STAFF RECOMMENDATION

306 South 15th Street

March 17, 2021

Application: New Construction—Outbuilding; Setback Determination

Project #: 0000
Date: 02-28-2021
PLANS & ELEVATIONS

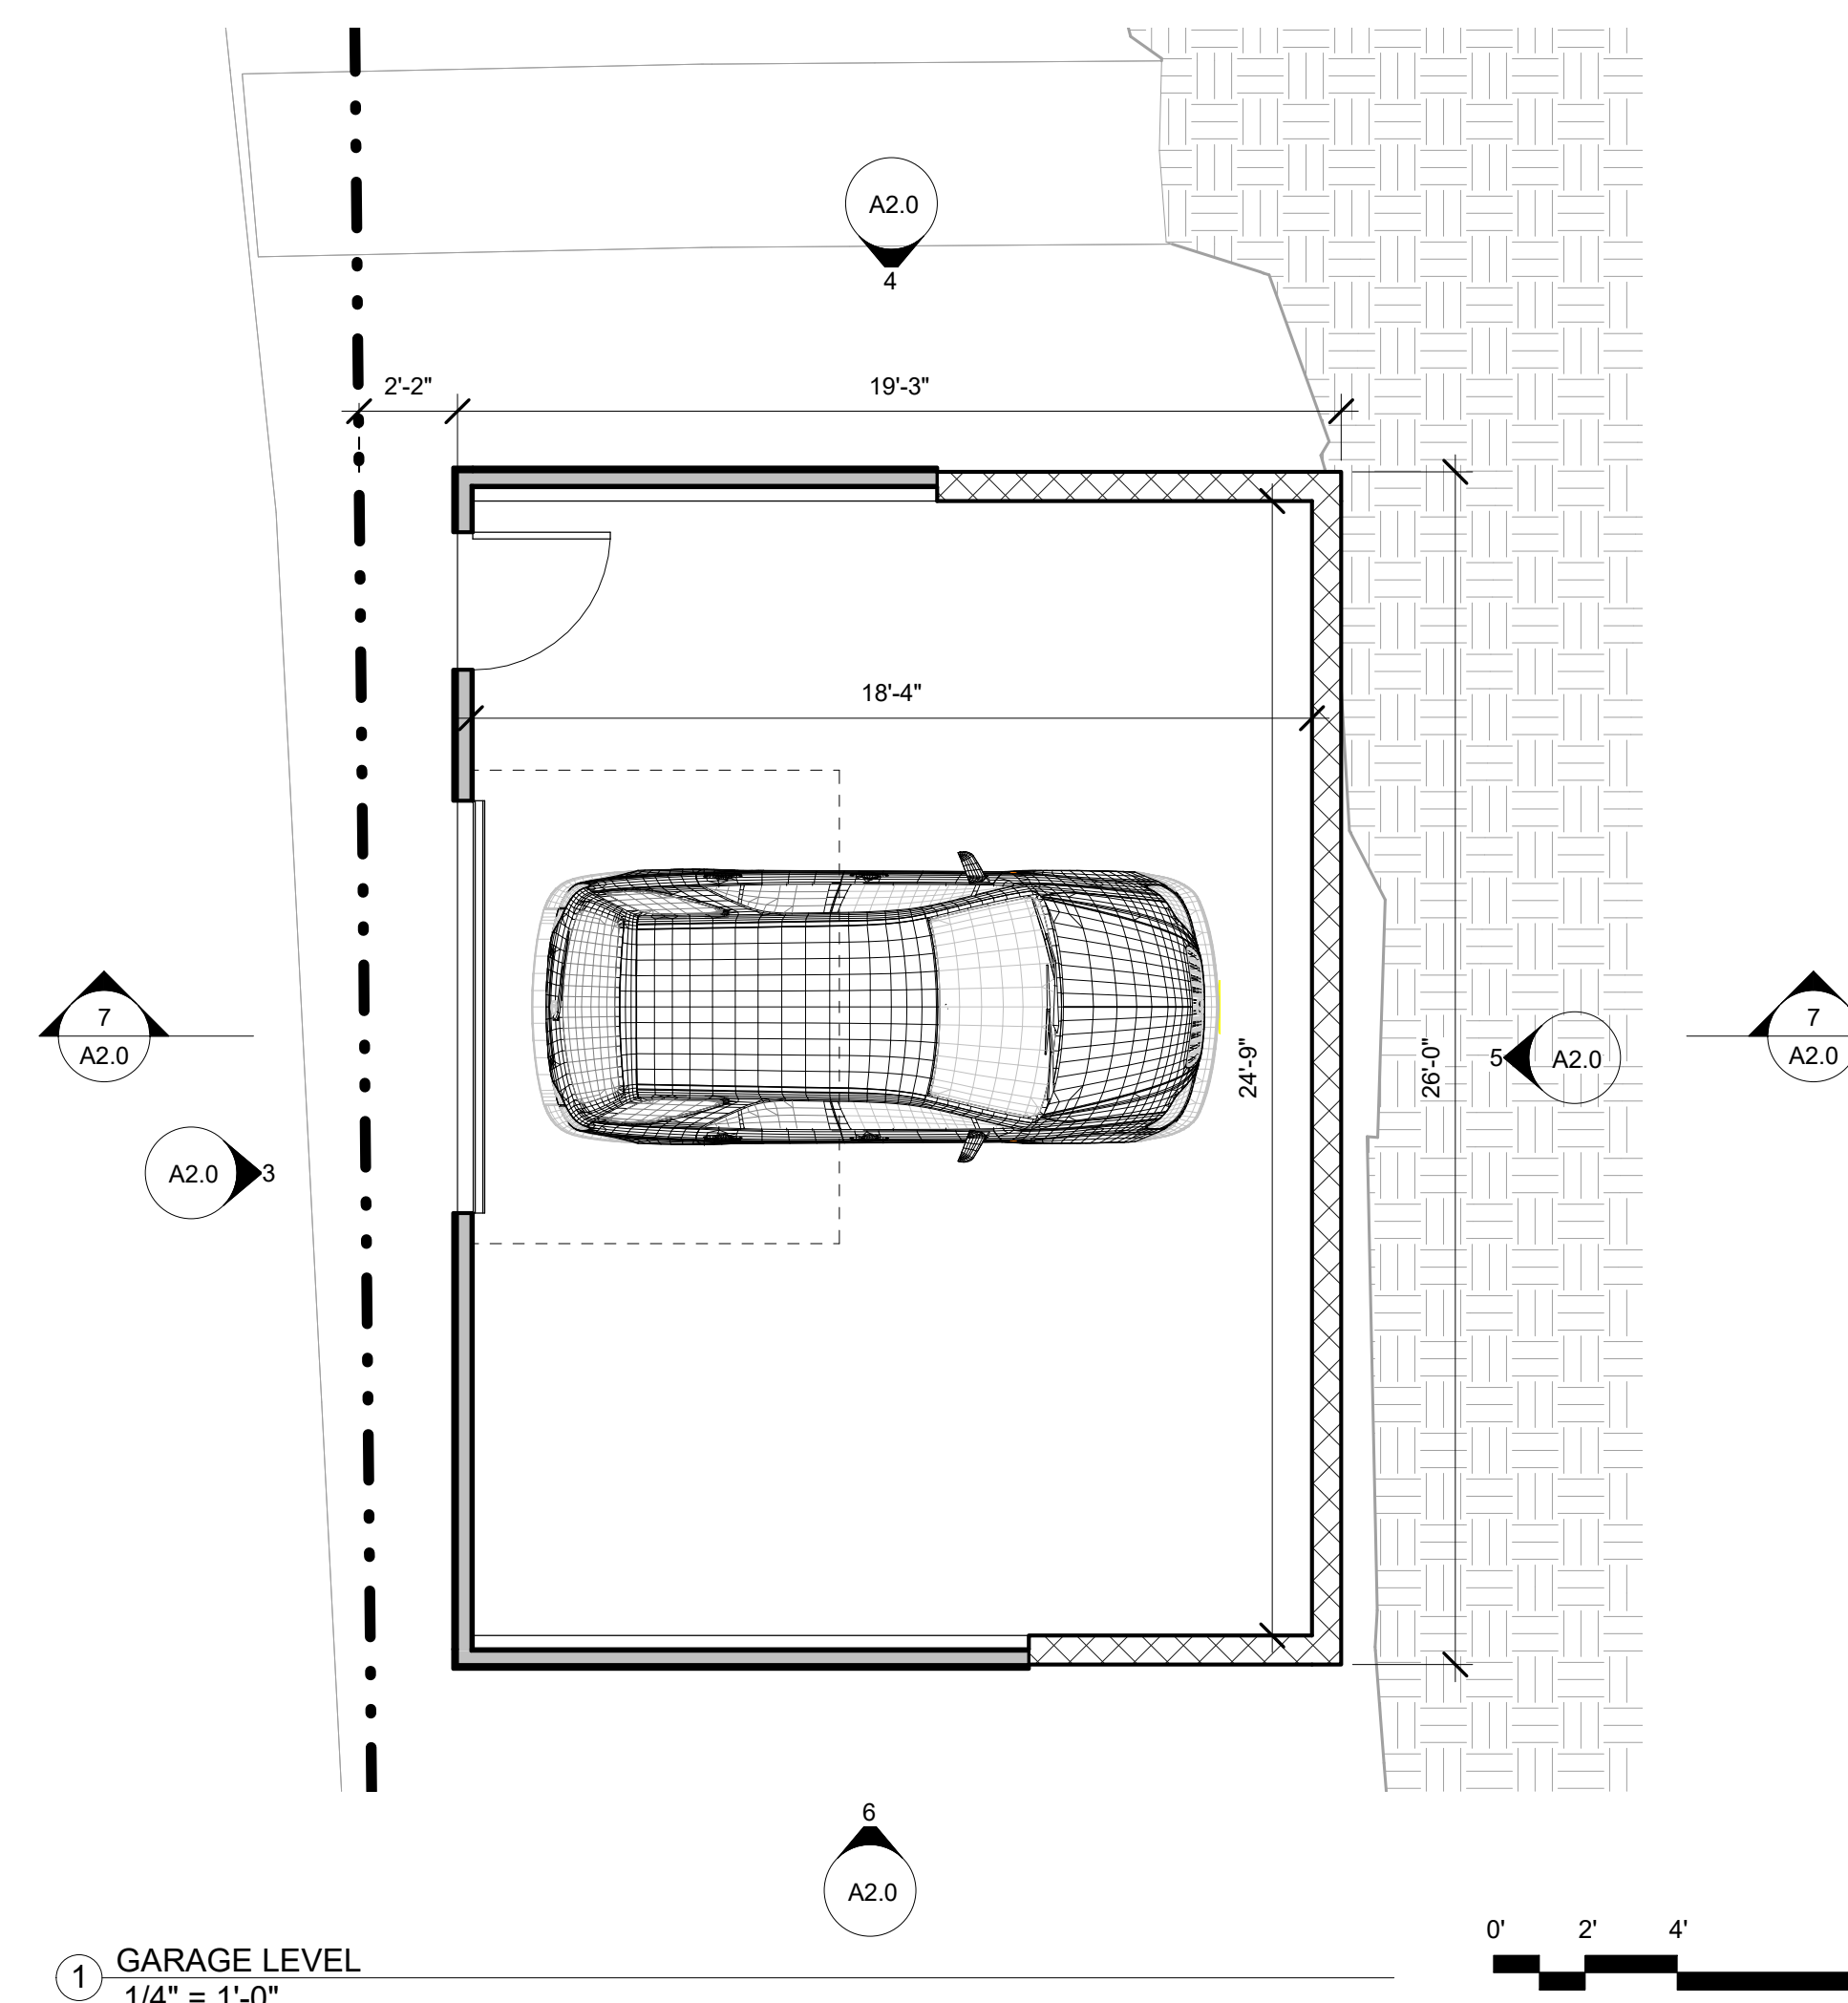
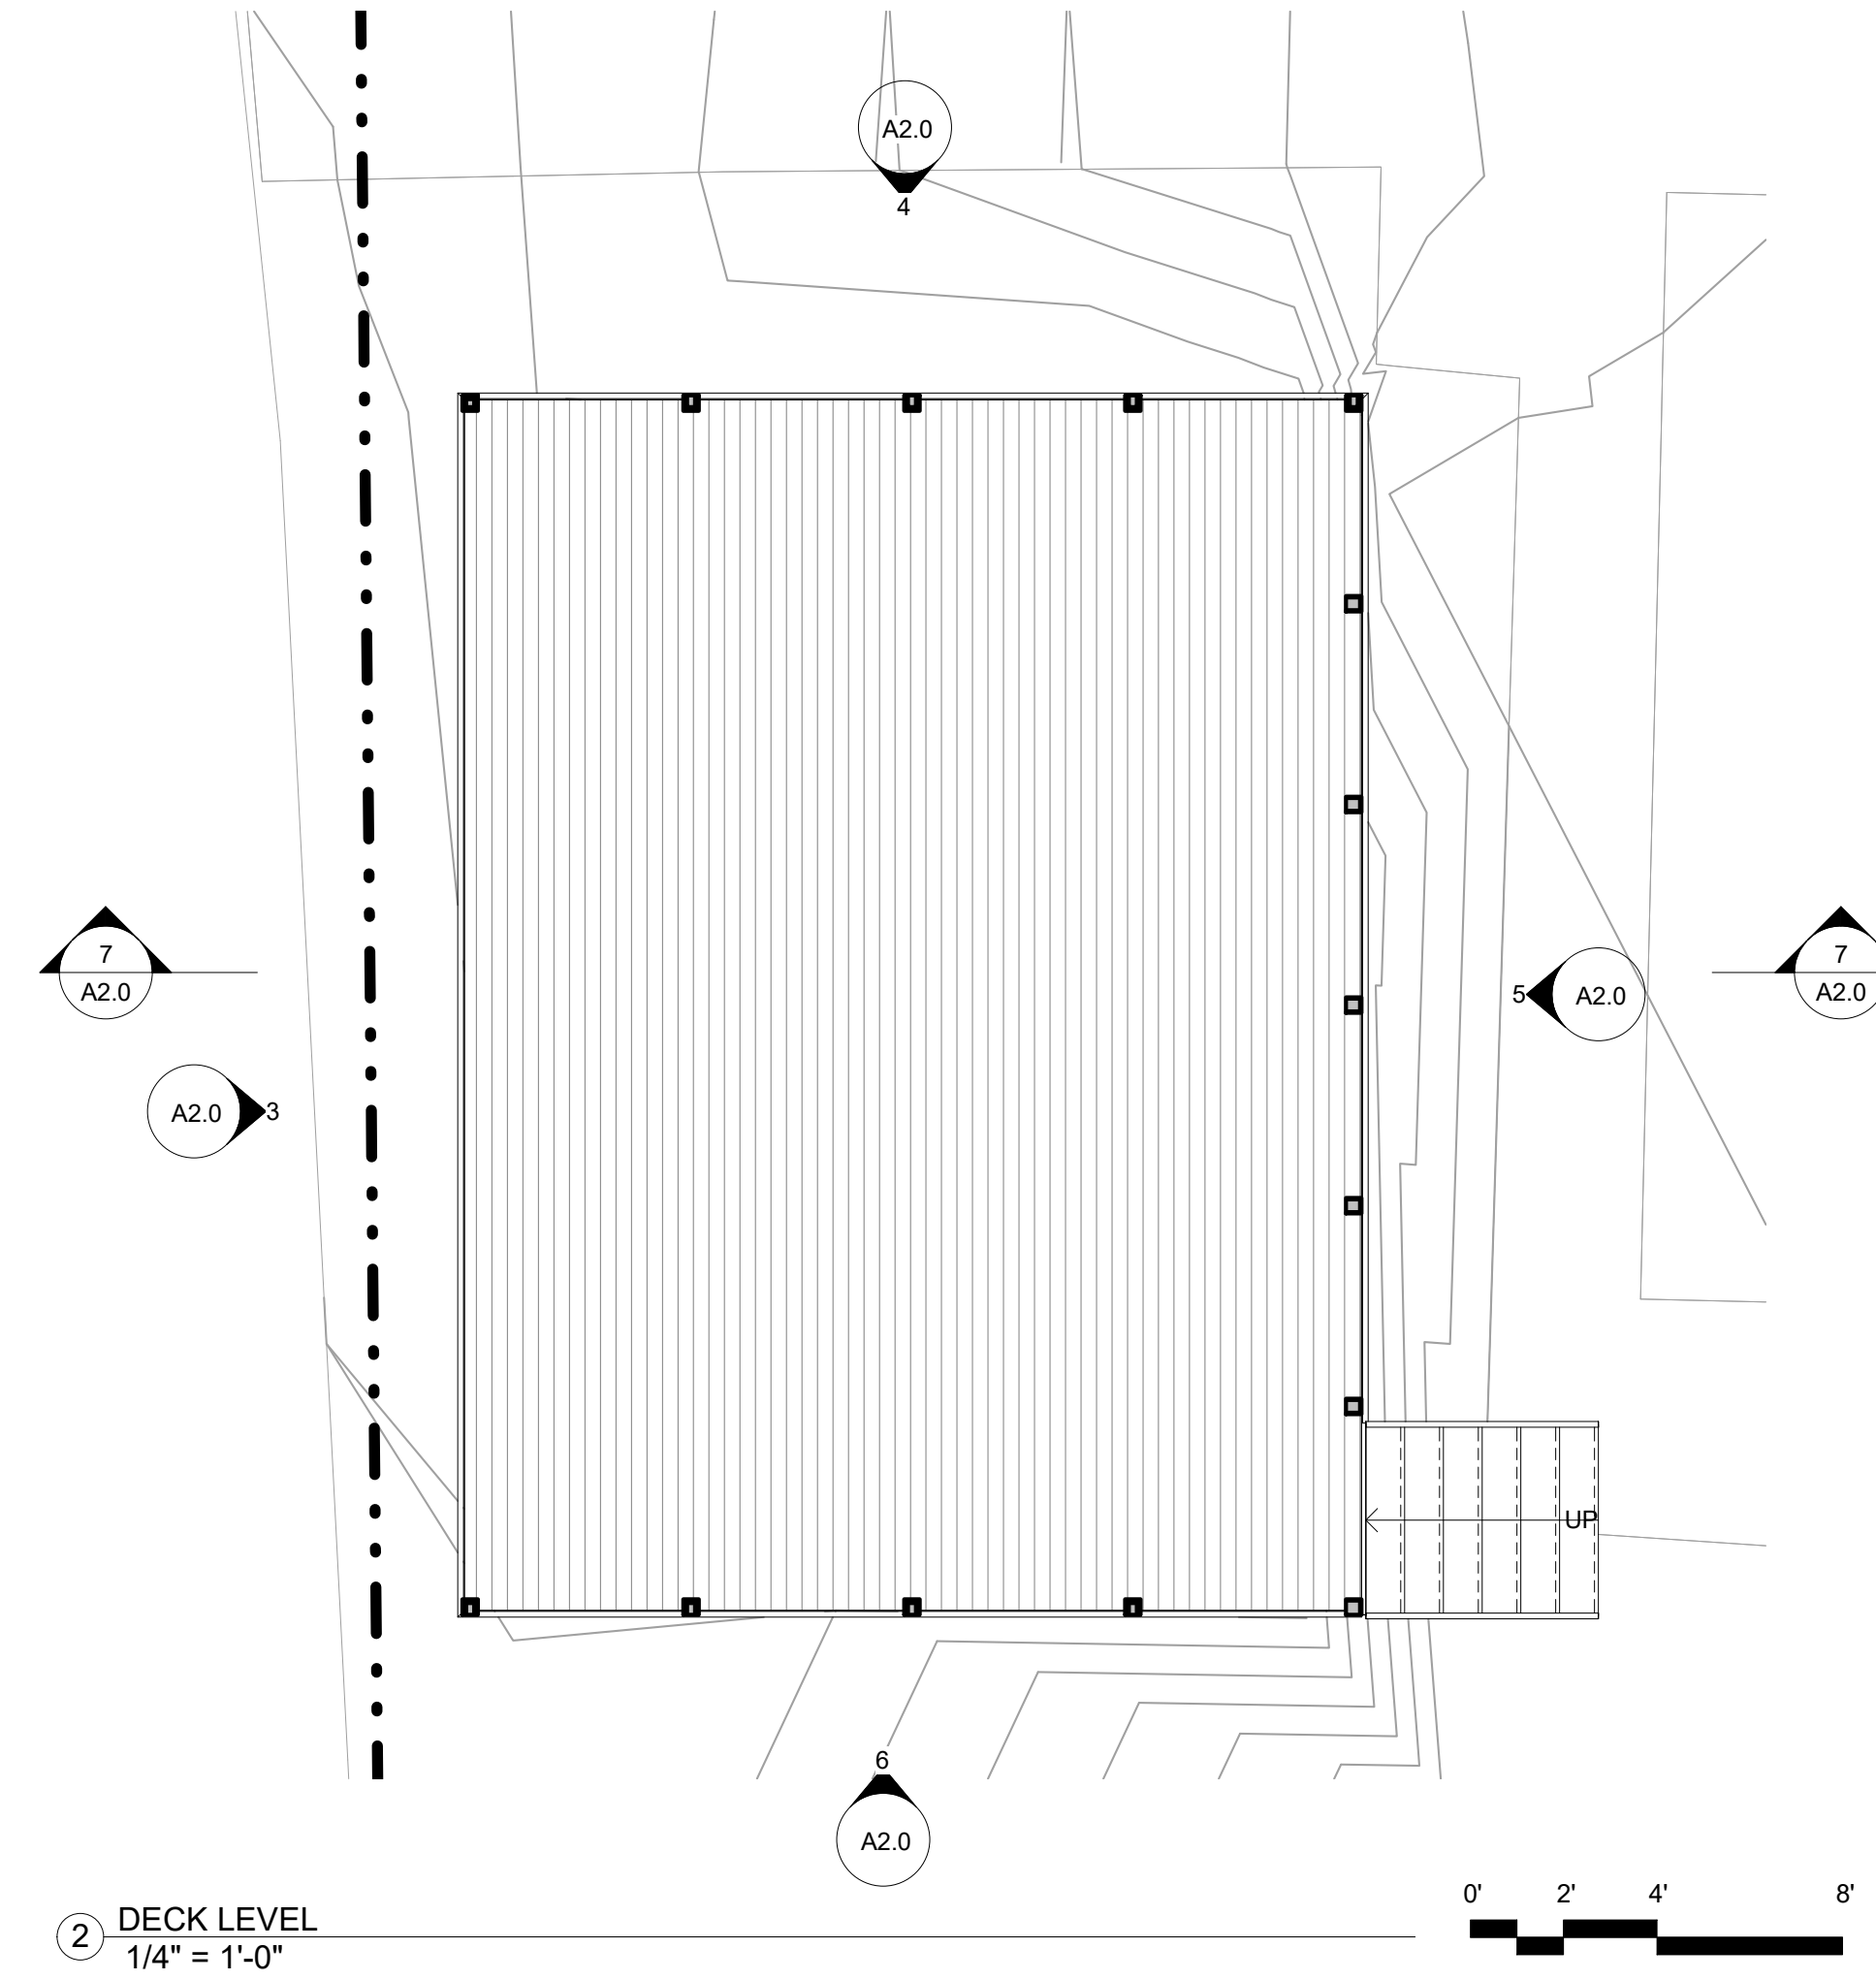
The outbuilding has a flat roof, so both its ridge and eave heights are approximately ten feet (10'). There is a railing that will add another three feet, six inches (3'6") above the roof. Staff find that this railing and its additional height meets the design guidelines because overall, the structure is still lower in height than the historic house.

** The garage has a flat roof rather than a 4/12 or larger roof slope. The Commission has approved flat roofs for outbuildings when the outbuildings are one story in scale and otherwise have an appropriate height and scale, like the proposed. Staff therefore finds that the flat roof meets the design guidelines.

With the condition that the concrete block be split faced and that staff approve the doors, staff finds that the known materials meet Section II.B.8 of the design guidelines.

1. The rear setback be at least five feet (5');
2. The concrete block be split face; and,
3. Staff approve the doors prior to purchase and installation.
